Access Compliance Report

Public Rights-of-Way

(Pedestrian Signals)

Intersection ID: N/A	Main Street:	Cross Street: N/A	Location: N/A
ADA ID: 6C549064E0EF	Signal Type: Two Push Buttons-APS	Overall Compliance: No	Severity Score: BTN 1:N/A BTN 2: N/A No BTN: N/A
Codes/Mitigation Info/Possible Solution		Field Measurements/Component Compliance

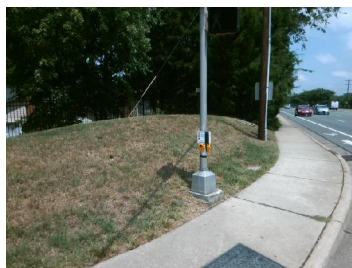
Possible Solutions: Replace Signal Push Button With APS Button on New Post.
Remove & Relocate Sign. Remove & Replace Replace APS Button With New APS Button.
Remove and Replace Clear Space.

PROW/ADA: TMUTCD 4e.08, R404.2, R404.3, R406.2,
